Department; <b>Marine Research Institute</b>	Ship Type; <b>170,000 m<sup>3</sup> LNG FSRU</b>	Class.; <b>DNV</b>
Hull No.; <b>HN2074</b>	Ship Name;	
Approved by ; <u>H. B. Yoon</u> Checked by ; <u>G. J. Gweon</u> Prepared by ; <u>J. C. Lee</u>	Document Title; <b>SAFETY REPORT</b>	
	Buyer's Document No.;	
<b>SAMSUNG HEAVY IND. CO., LTD.</b> <b>GEOJE SHIPYARD, KOREA</b>	Builder's Document No.;	Rev. No.;
	<b>3000 - HX - 71001</b>	<b>1</b>
Scale; NONE	Unit; -	Consolidated No.;
		-

Department; DS <b>Outfitting System Design 1</b>	Ship Type; <b>170,000 m<sup>3</sup> LNG FSRU</b>	Class.; <b>DNV</b>
Hull No.; <b>2031</b>	Ship Name;	
Approved by ; <u>Y. S. Kim</u> Checked by ; <u>Du. H. Ha</u> Prepared by ; <u>G. J. Gweon (T.6178)</u> <i>G. J. Gweon</i>	Document Title; <b>HAZOP REPORT FOR REGASIFICATION PLANT</b>	
<b>SAMSUNG HEAVY IND. CO., LTD. GEOJE SHIPYARD, KOREA</b>	Buyer's Document No.;	
	Builder's Document No.;	Rev. No.; -
Scale; NONE	Unit; -	Consolidated No.; -

## FINAL REPORT for HN2031 HAZOP recommendation

HAZOP REPORT  
FOR  
REGASIFICATION SYSTEM OF  
HN2031 170,000m<sup>3</sup> LNG FSRU

### HAZOP MARKED-UPS P&ID

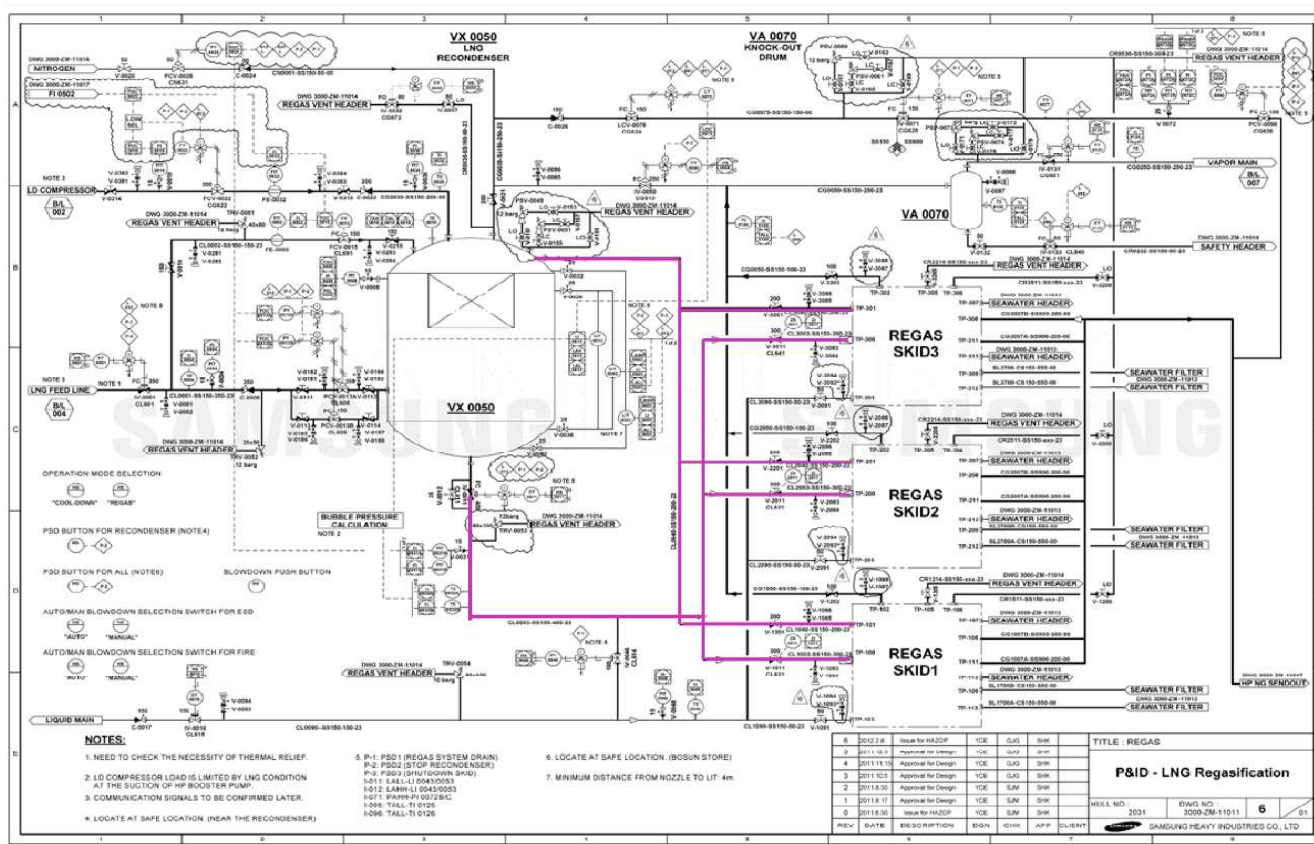
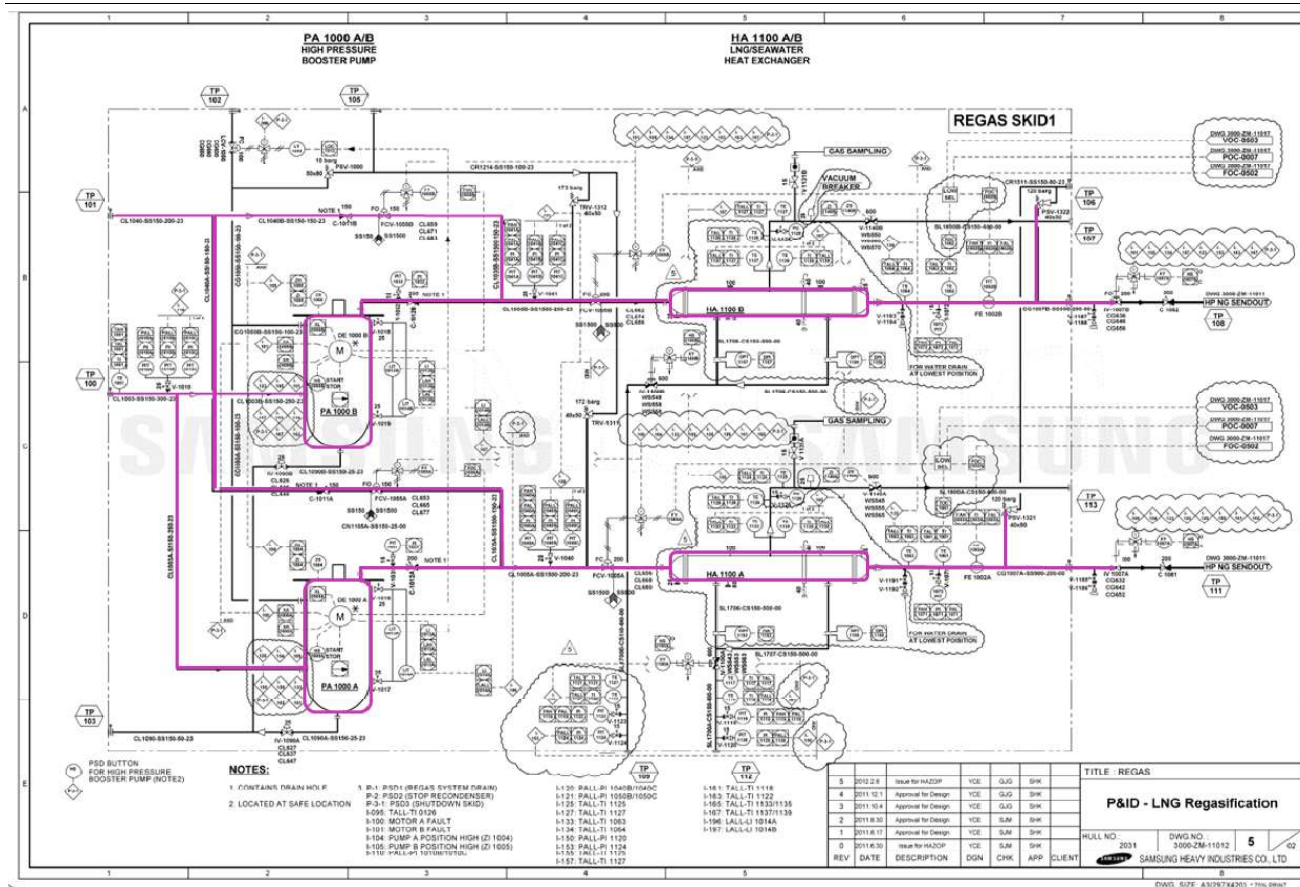
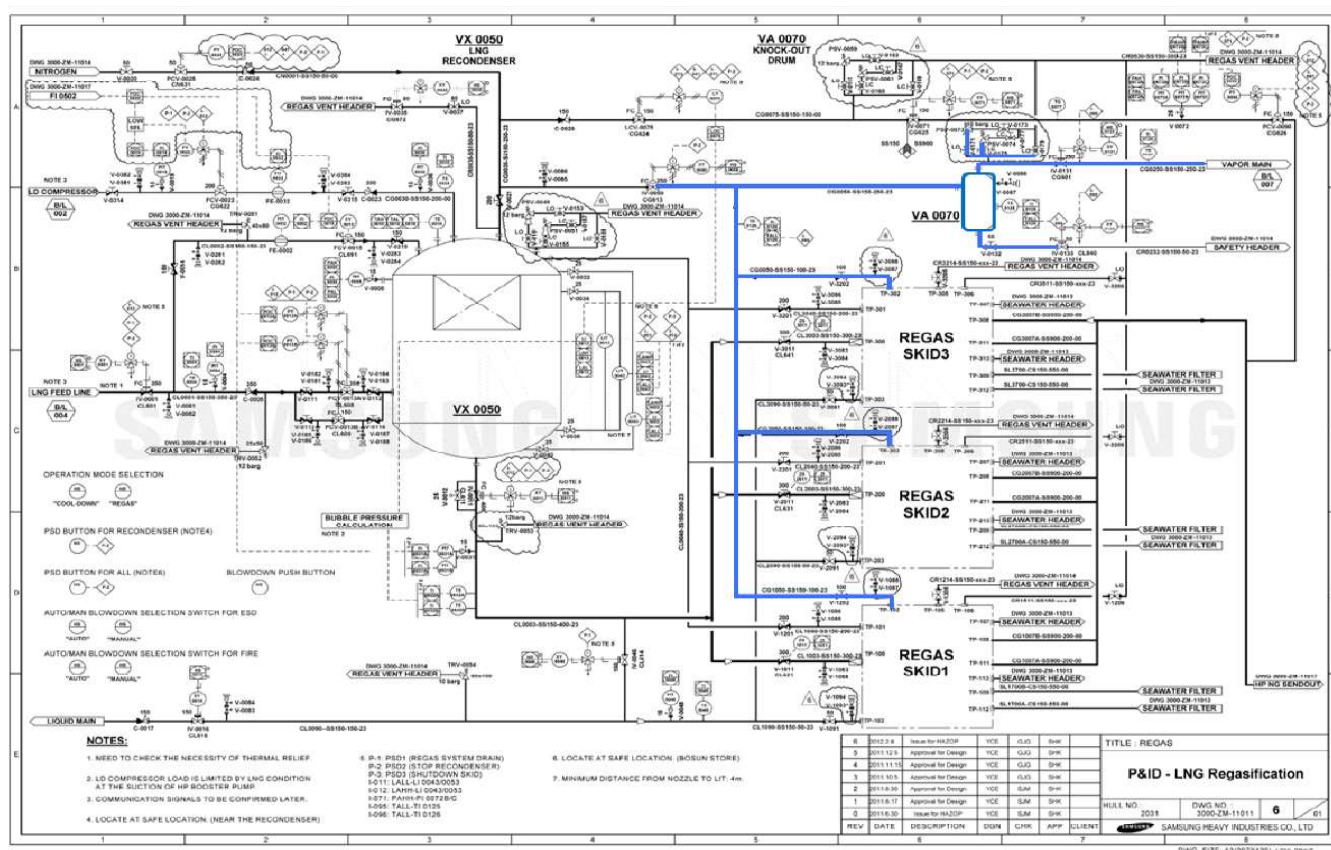
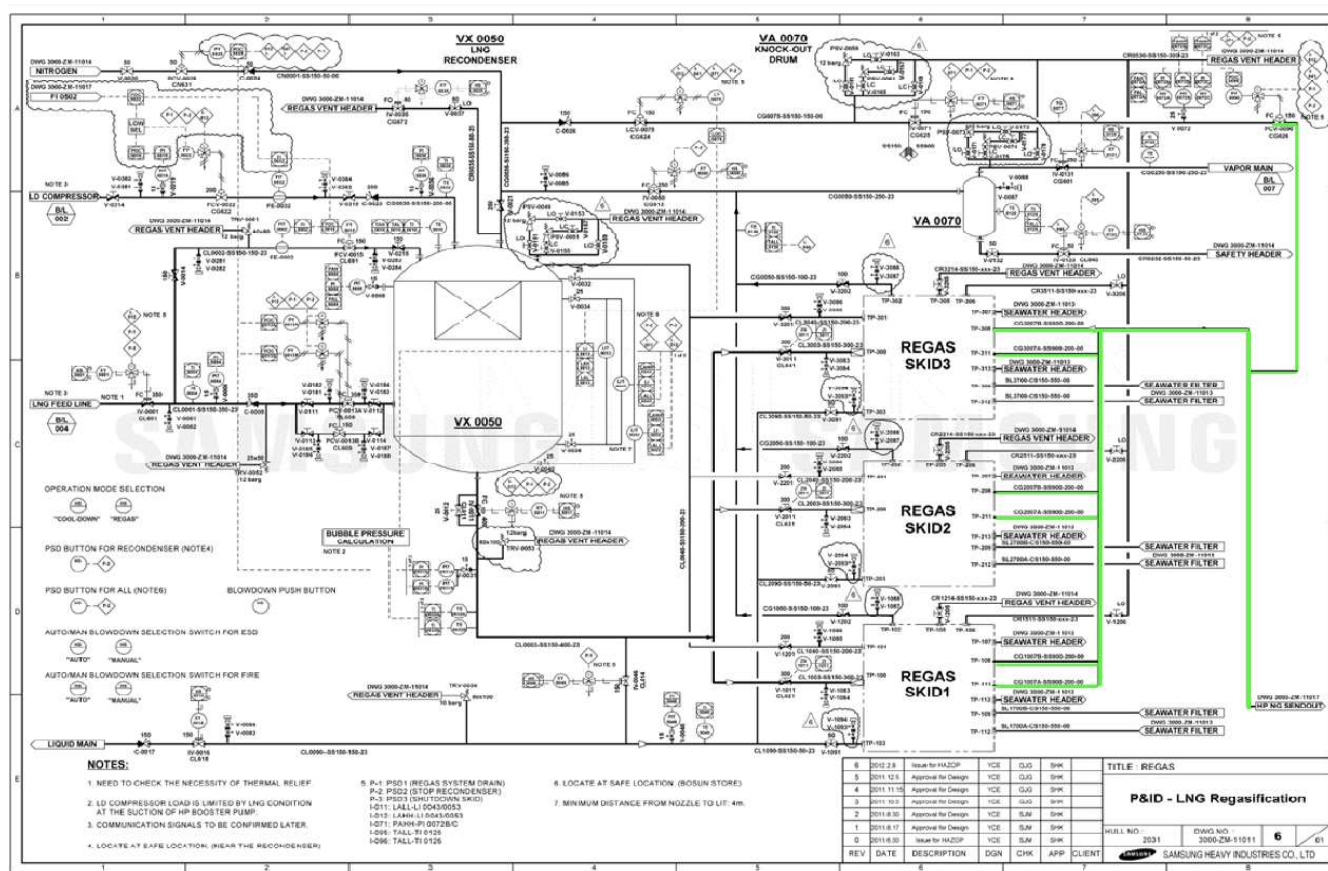
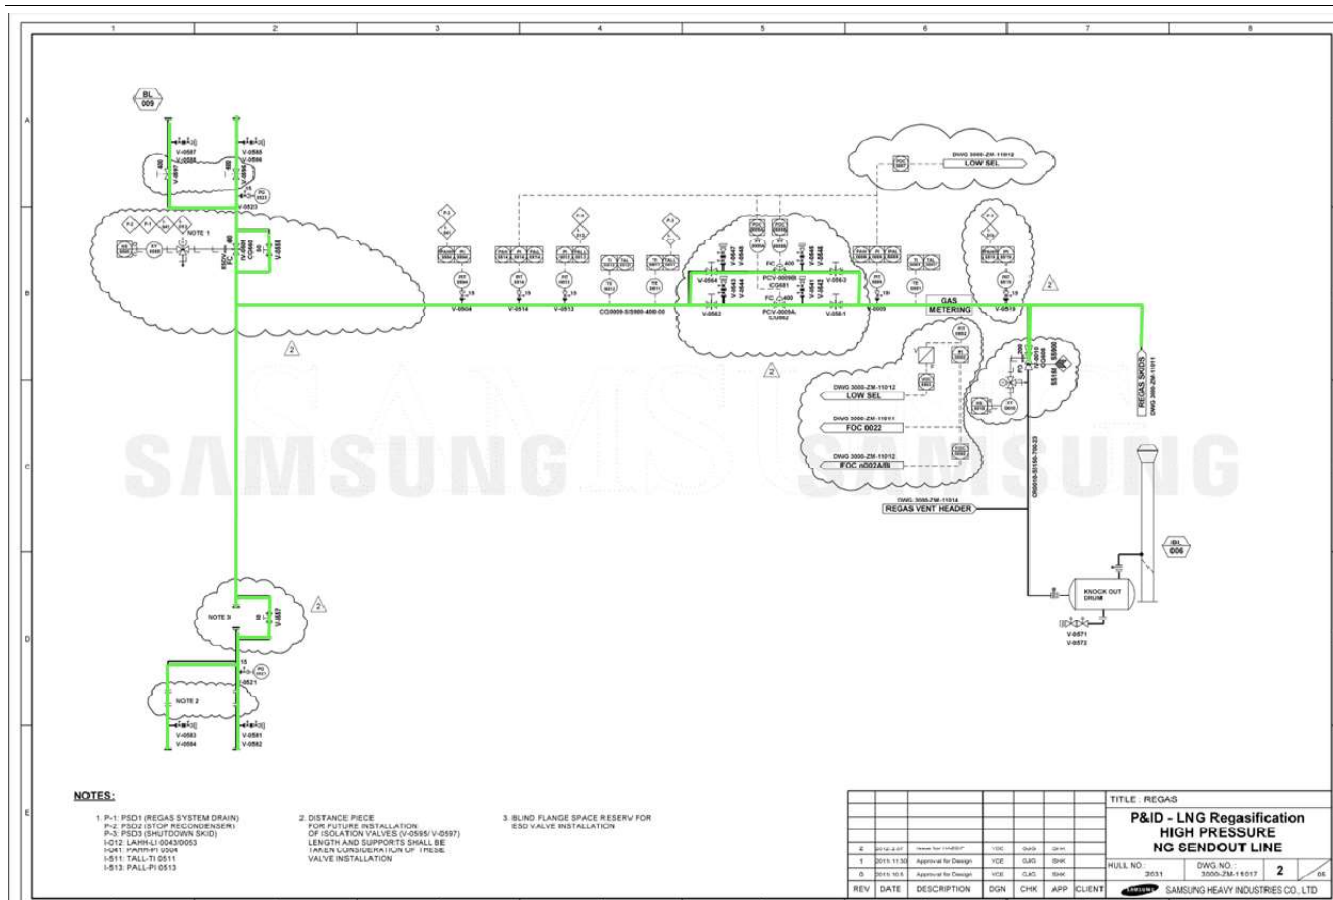
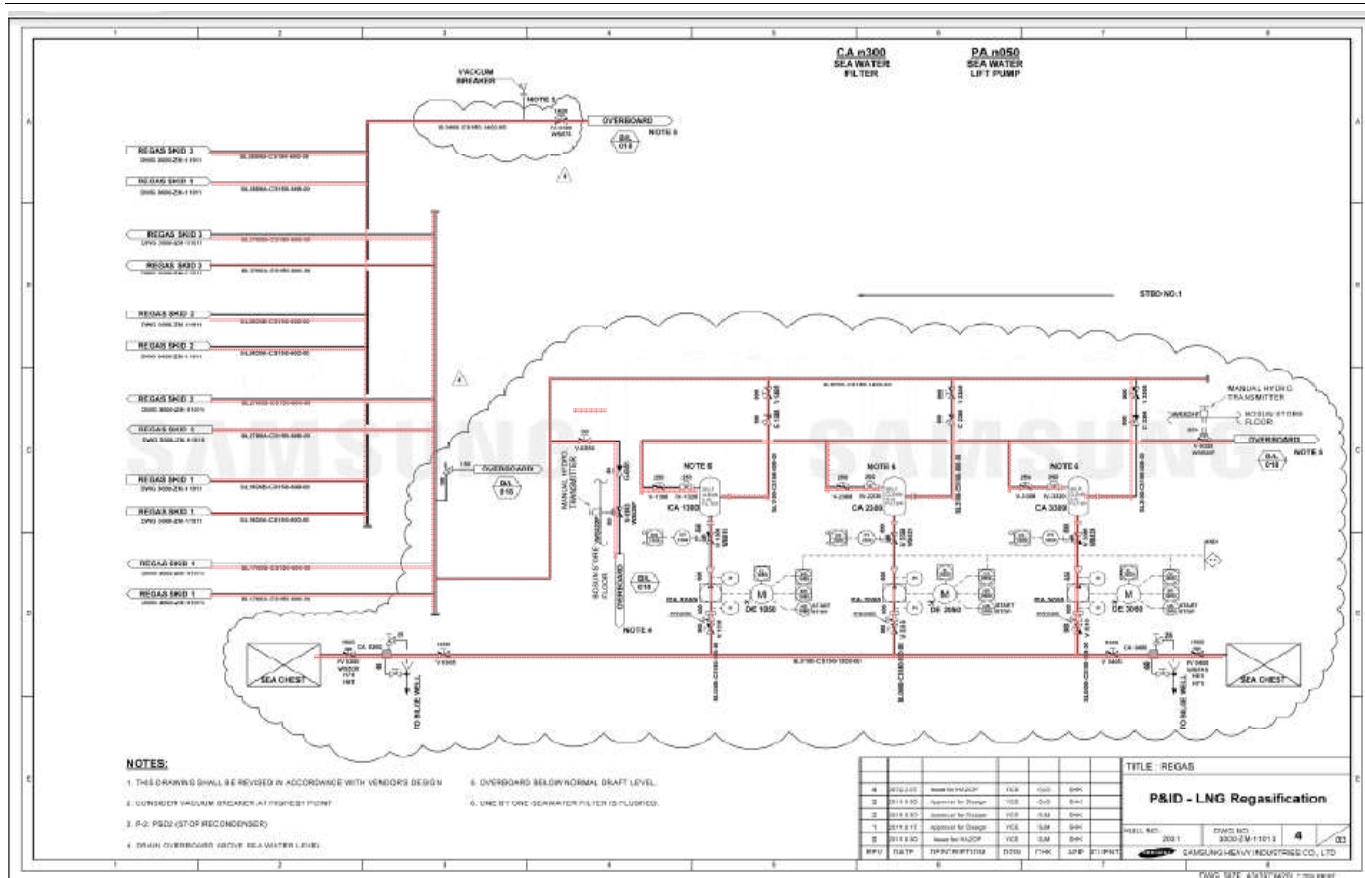
REC #	RECOMMENDATION	ACTION BY	REMARKS <sup>1</sup>
1.1	Consider using three transmitters for action voting for LAHH and LALL to transmitter LIT-0013.	SHI / Golar	
1.2	Consider three independent pressure transmitters each with dedicated shut-off valves.	SHI / Golar	
1.3	Clarify the control strategy for the high pressure controller on Recondenser VX-0050.	SHI / Golar

3.3	Consider to include PAHH on the PIT-1071 and PIT-1072.	SHI / Golar	
3.4	Consider to include PAHH on the PIT-1041 A/B/C and PIT-1040 A/B/C.	SHI / Golar

3.5	SHI to confirm the low current signal trip	SHI / Golar	
3.6	Confirm the capacity of the PSV-0049 and PSV-0051.	SHI / Golar	
3.7	Consider moving the spec-break downstream of the valve.	SHI / Golar	DNV considered the possibility for check valve C-1011A/B being stuck in closed as unlikely. The proposed design is therefore acceptable.

3.8	Consider moving the check valve to inside the Regas Skid.	SHI / Golar	
3.9	Consider suitability of the use of control valve for safety shutdown.	SHI / Golar	DNV confirmed that it is acceptable to use the control valve FCV-1005A/B for both flow control and PSD due to solenoid valve separating functions and the additional safeguards in the system.

REC #		ACTION REQUIRED	ACTION BY	SHI REPLY	OWNER REPLY		STATUS
1.1	a)	Consider using three transmitter for action voting for LAHH and LALL to transmitter LIT-0013	SHI	Voting function for LAHH and LALL with LIT-0013/LIT-0043/LIT-0053 will be provided. Please refer to the revised P&ID as attachment #1.1-a.	Accepted		CLOSED

1.2	a)	Consider three independent pressure transmitter each with dedicated shut-off valves	SHI/GOLAR	Pressure transmitter PIT-0031C will be added without shut-off valve(root valve) due to having individual three-way valve. Please refer to the revised P&ID as attachment #1.1-a.	Arrangement in revised drawing is accepted. However, considered the consequences of faulty instrument this should be included in Yard supply without extra cost.		CLOSED

1.3	a)	Clarify the control strategy for the high pressure controller on Recondenser VX-0050	SHI	Please refer to the revised Control philosophy as attachment #1.3-a.	Revised control philosophy noted. Owner would suggest that LCV-0075 closes at 10 bar. Pre-alarm should be given at 8 bar.		CLOSED

3.4	a)	Consider to include PAHH on the PIT-1041 A/B/C and PIT-1040 A/B/C	SHI	PAHH on the Pressure transmitter PIT-1040 A/B/C and PIT-1041 A/B/C and voting function will be provided for trip condition. Please refer to the revised P&ID as attachment #3.3-a.	Revised design is accepted.		CLOSED
